Exhibit List: Z0032-23-D

## **RECCOMENDATION TO THE DESIGN REVIEW COMMITTEE**

**File No.** Z0032-23-D

**Proposal:** Development of 47-room hotel with associated hotel amenities. This review is also subject to a Stream Conservation Area (SCA) development associated with Camp Creek, running in the southern sector of the property. That proposal is being reviewed under planning file # Z0033-23-R.

**Building Elevations**

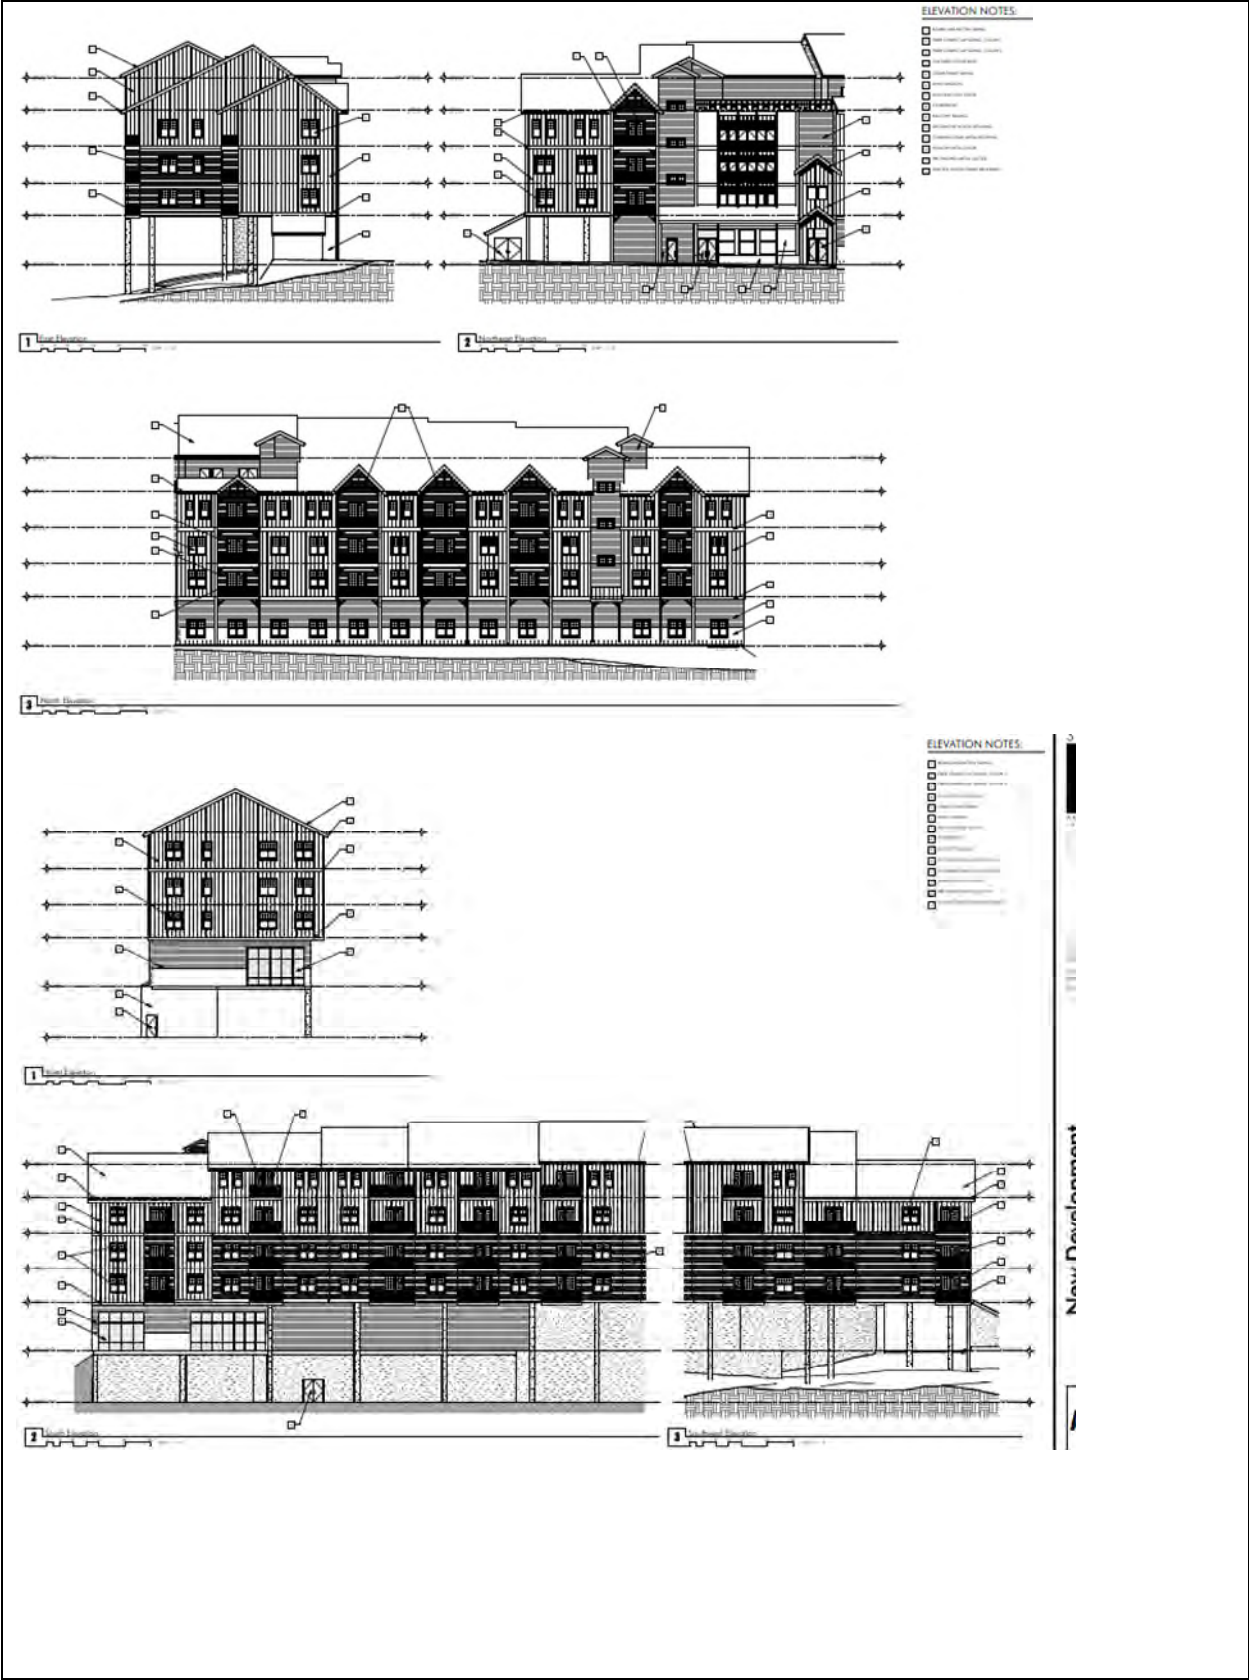
*Subsection 1005.03(D) and (E): Findings: Pitched roofs are proposed and eaves are proposed on the applicant's plan set. The applicant shall ensure final building plans show roof eaves at 24 inches minimum, with roof vents placed opposite the public entrance. This criteria can be met as conditioned. The applicant's architectural plan set shows a variety of external materials that are required in Subsection E. These standards can be met, and a condition of approval is recommended that building plans show these items are included prior to building permit approval, and prior to final occupancy.*

*Subsection 1005.03(I) and (J): Findings: The applicant's submittal plan appears to meet items 1-9, Subsection I. Item 7 requires design to reflect the "unincorporated communities" appearance. Staff finds that the design is comparable to other development in Government camp. Staff notes, there will be additional standards for Government Camp, noted in subsection 1005.12, below. It also appears that the structure will be largely wood/brown in color, so this should blend with the Open Space/natural areas, as noted in item 9. For Subsection J, a condition of approval is required that all mechanical equipment shall be screened from view by the measures noted in items 1-3, subsection J. These standards can be met.*

***Finding:*** the applicant’s plan set appears to accomplish these design standards. Culture stone base, and various cement boards should articulate with the wood framing. Cedar shake siding is noted as building item #5 in the architectural drawings, but only a small area of cedar shake siding is proposed. Staff will review wood siding in subsection 3, below. Otherwise, staff finds that the proposed building materials should satisfy this section, and recommends the plans be accepted as sufficient except where noted below.

**MITIGATION AND RESTORATION PLAN**  
**MT HOOD LODGES DEVELOPMENT**  
 GOVERNMENT CAMP, OREGON

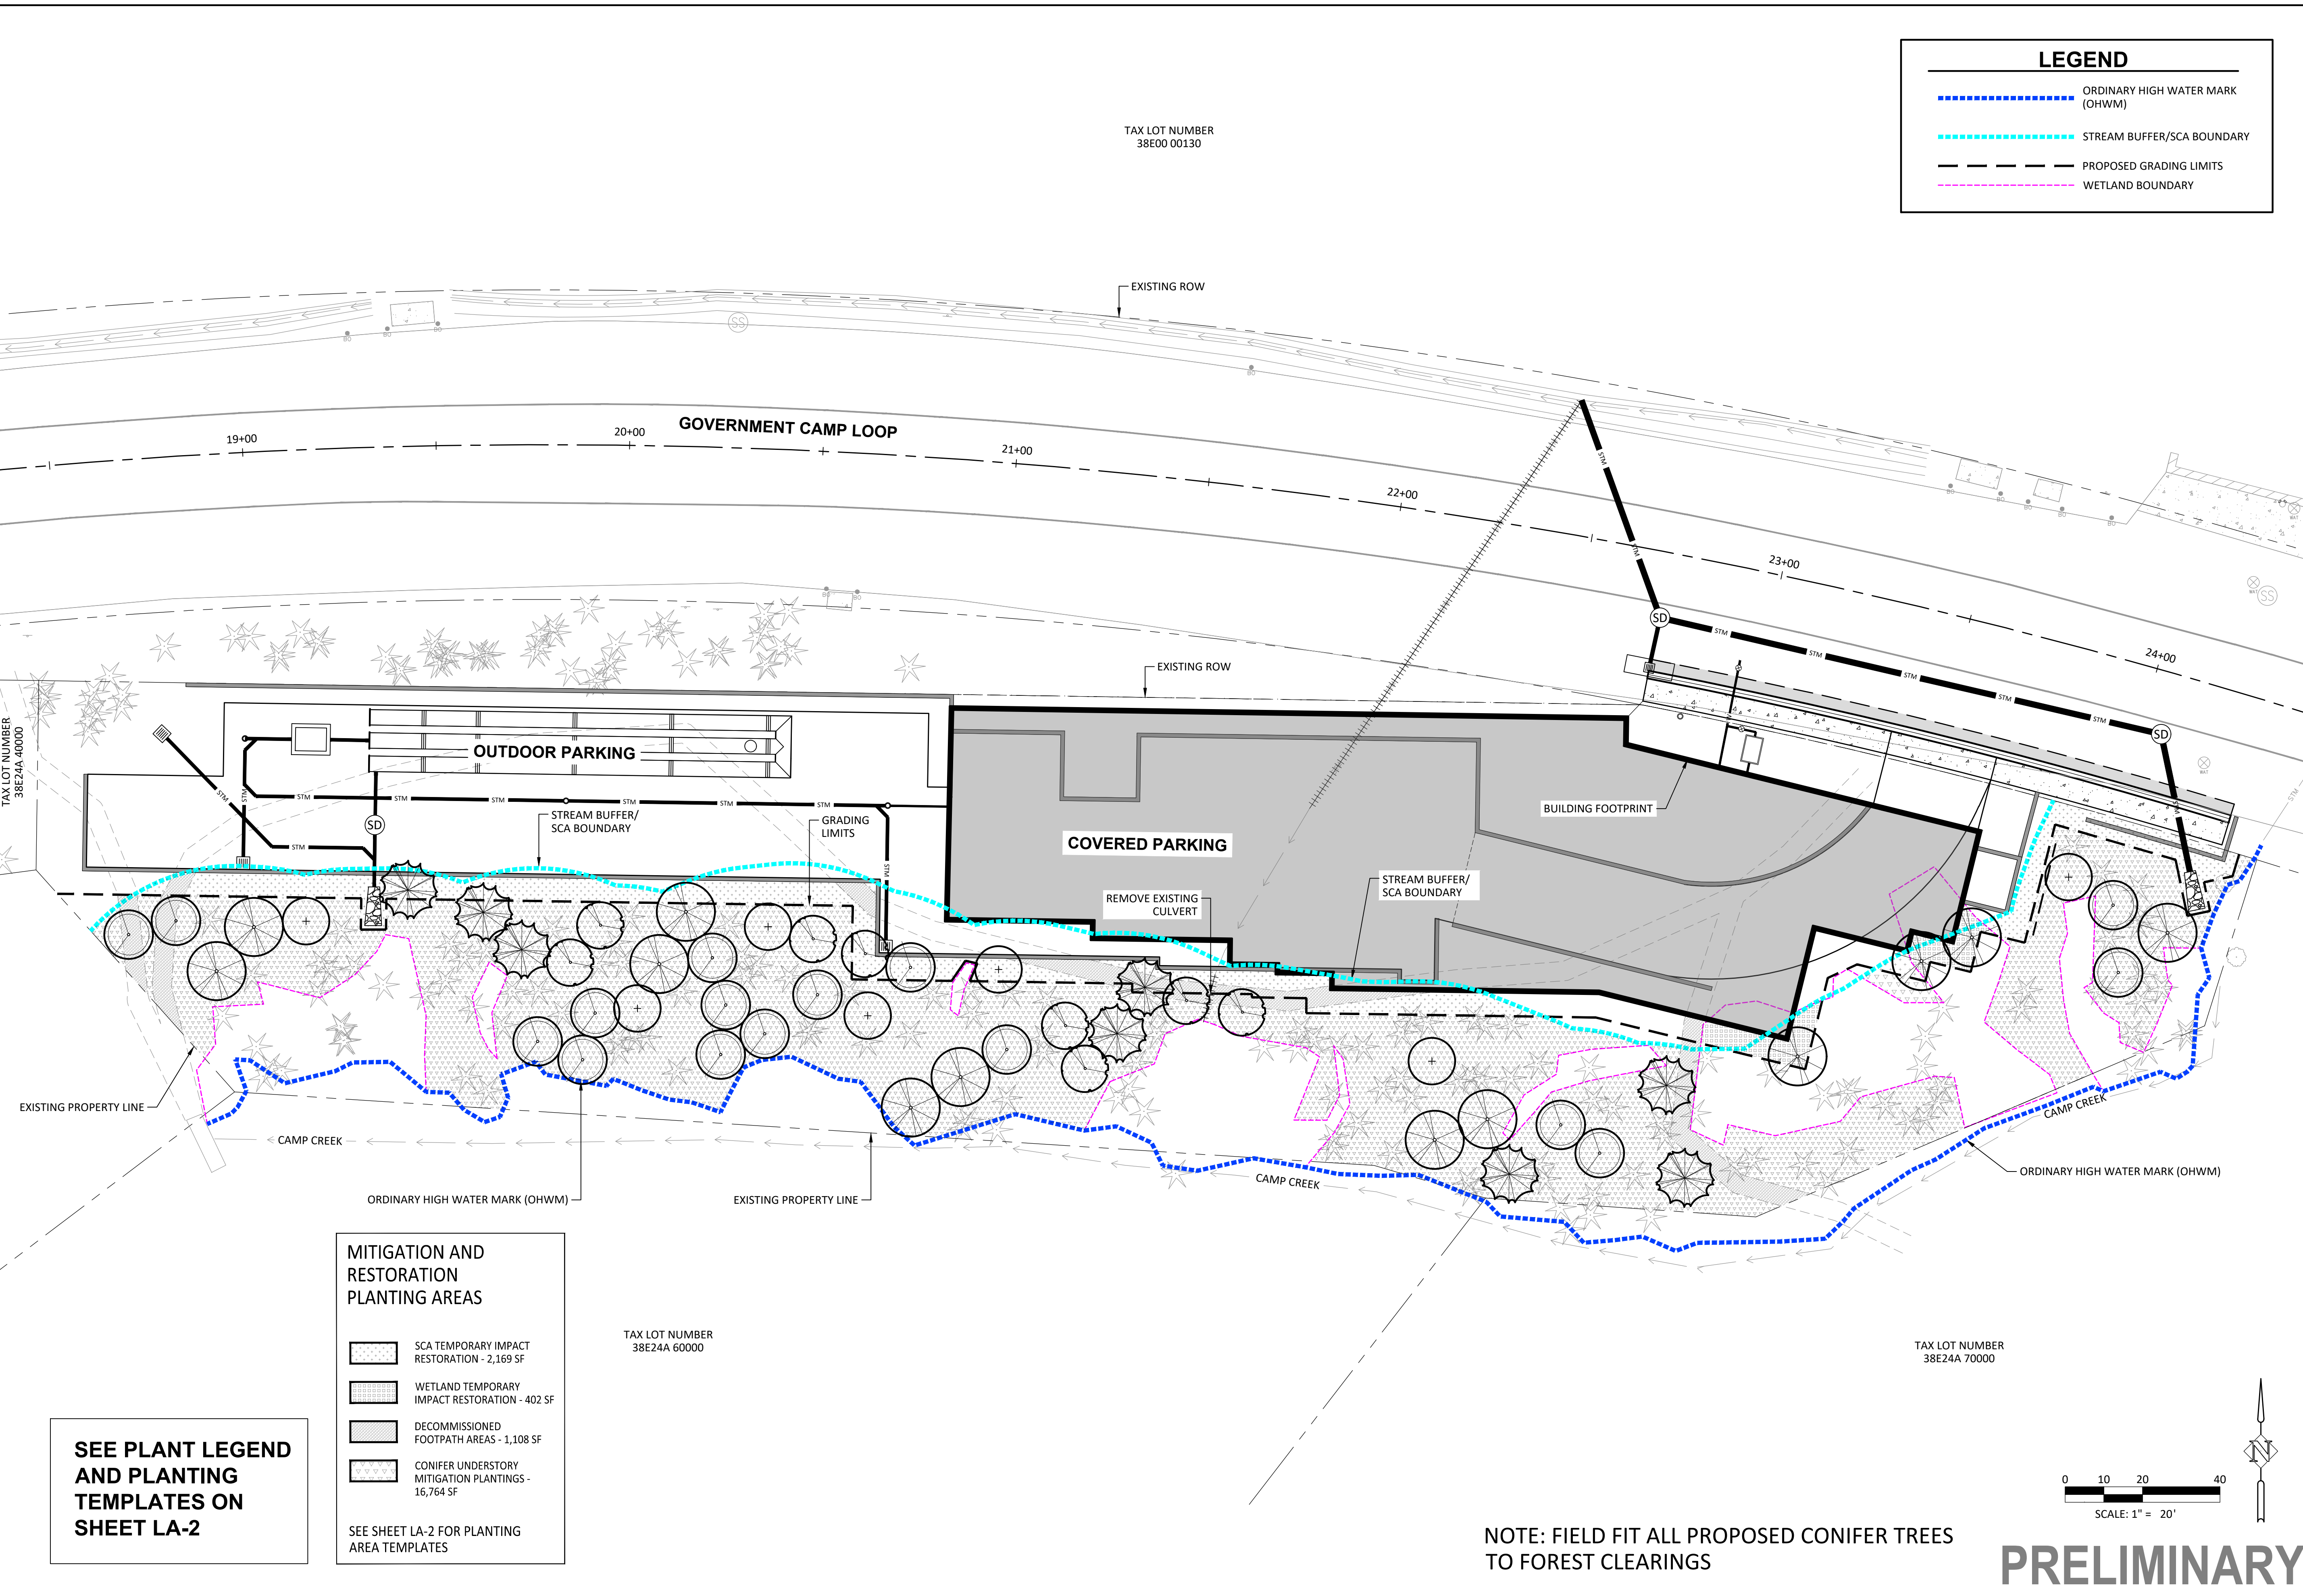
- A) **Exceptions to Buffers / Setbacks:**
  - i. The proposed hotel shall be located no closer to Camp Creek than is outlined on the submitted Mitigation & Restoration Plan, Sheet LA-1, dated November 2, 2022.
